# SAN FRANCISCO PLANNING DEPARTMENT

**RE:** PPA Case No. 2013.1496U for 1455 Folsom Street

## Preliminary Project Assessment

Enclosure:      Preliminary Shadow Fan

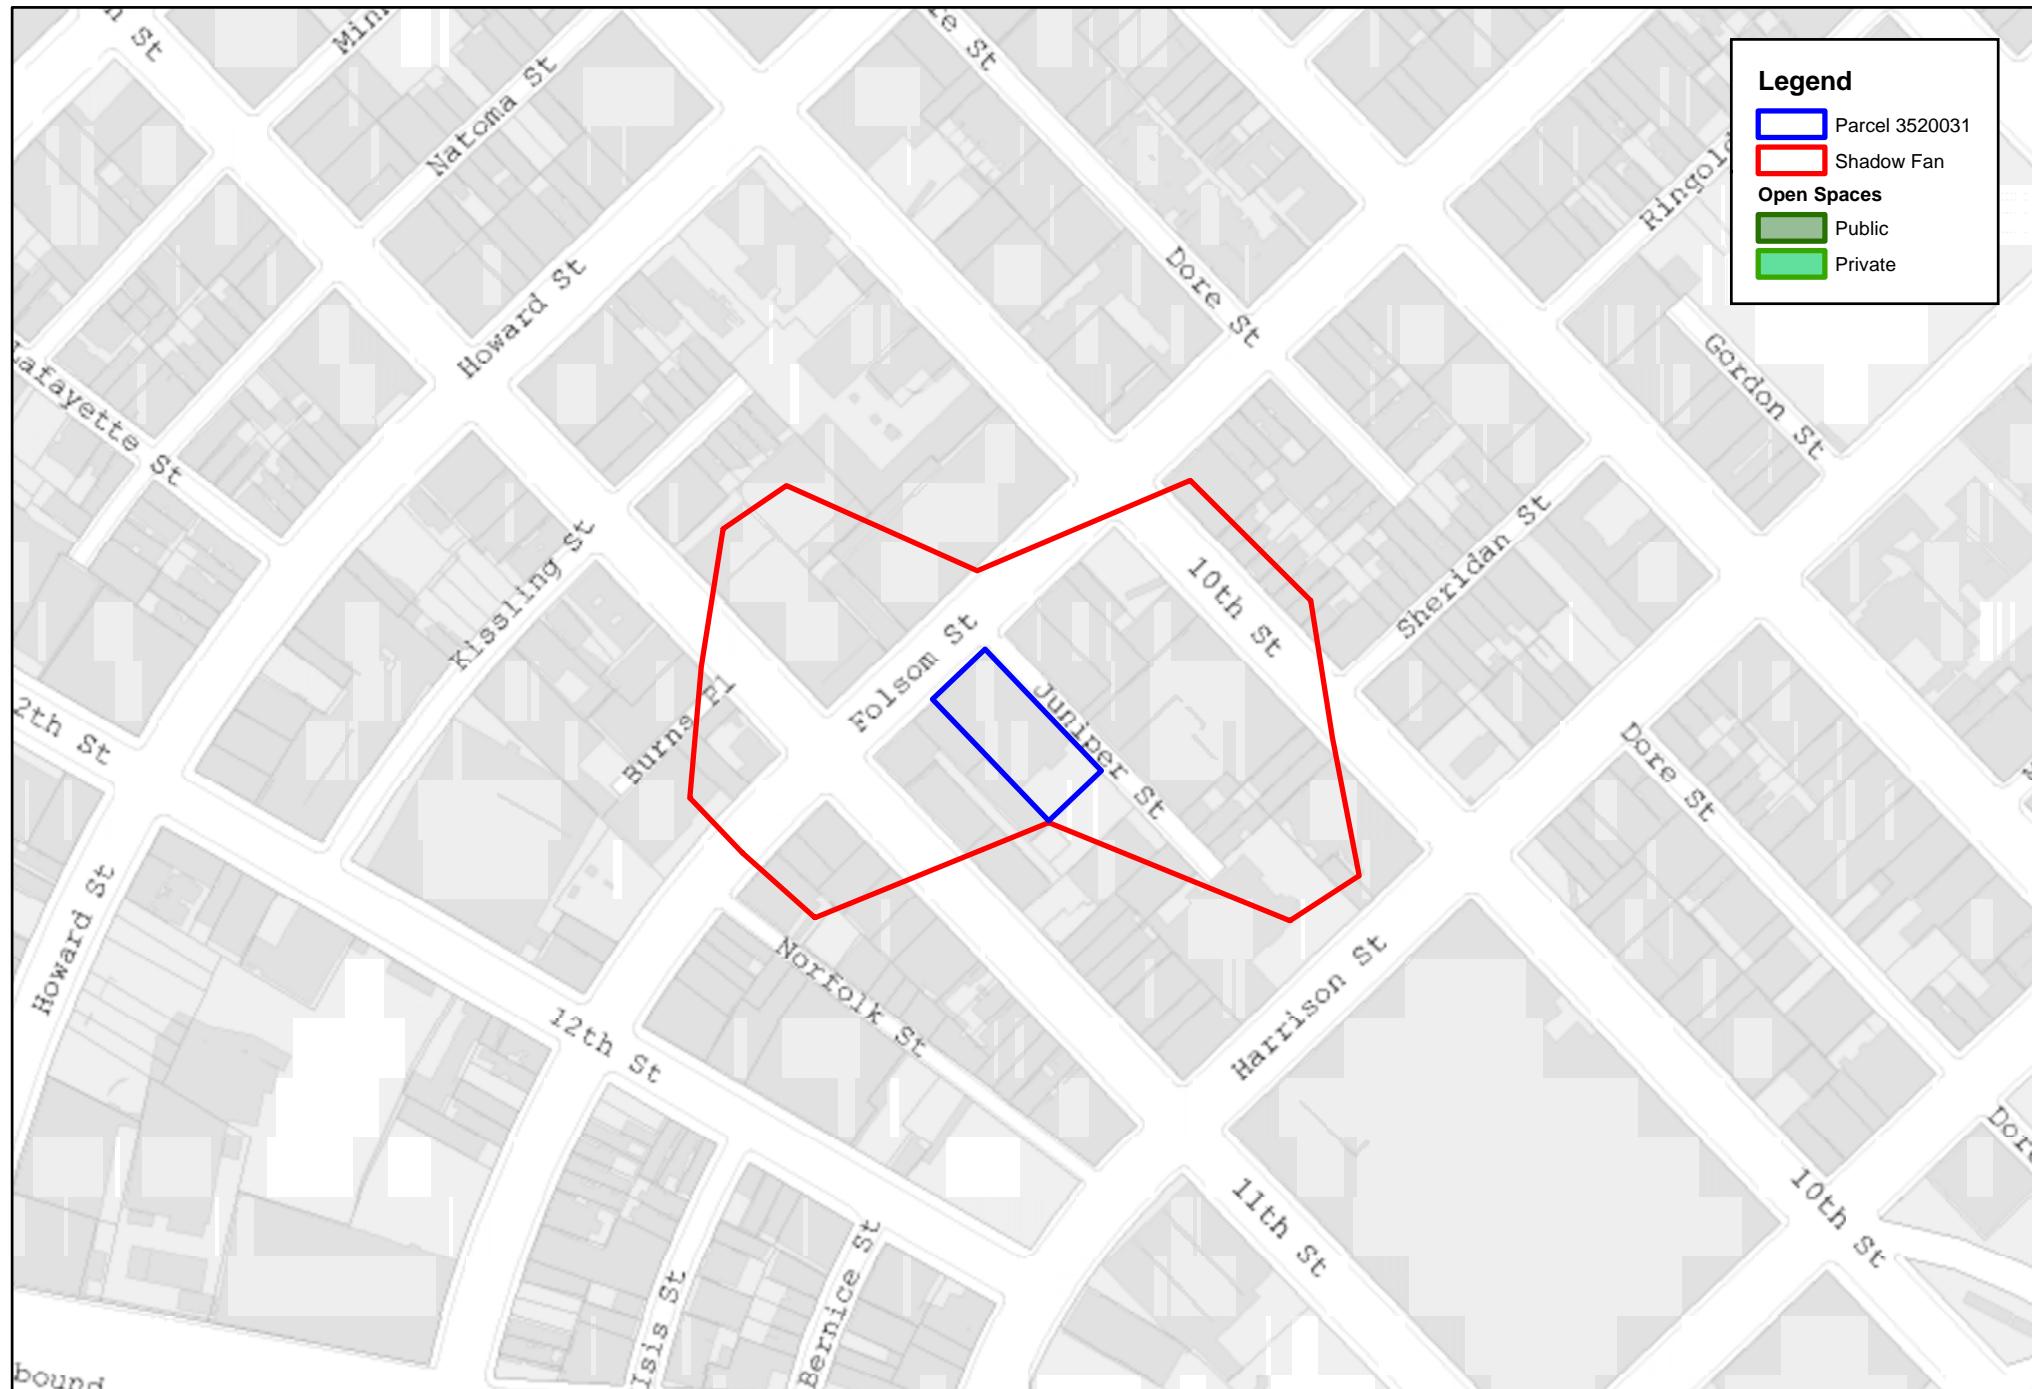
- **Shadow.** Section 295 requires that a shadow analysis must be performed to determine whether the project has the potential to cast net new shadow on properties under the jurisdiction of the San Francisco Recreation and Park Commission. Department staff has prepared a shadow fan that indicates the project will not cast net new shadow on any property under the jurisdiction of the Recreation and Parks Department.

15. **Shadow:** Planning Code Section 295 outlines requirements for projects with a height exceeding 40 ft that cast shadows on property under the jurisdiction of the Recreation and Parks Commission. As discussed above, under Environmental Review, based upon an initial shadow study, the proposed project would not impact any properties subject to Planning Code Section 295.
